Technical Service Bulletin

NUMBER: 18-017-01 REV. A

Engine Idle Undershoot/Performance

2000 - 2001 (PL) Neon

FIGURE 2 - AUTHORIZED MODIFICATION LABEL

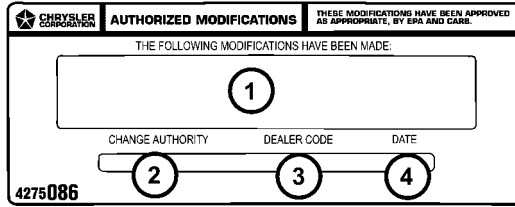
2. Type the necessary information on the “Authorized Modification Label” p/n 04275086 and attach the label near the VECI label (Figure 2).

1-	POWERTRAIN CONTROL MODULE P/N (INSERT P/N) USED
2-	CHANGE AUTHORITY: TSB XX-XX-XX
3-	DEALER CODE: XXXXX
4-	DATE: XX-XX-XX
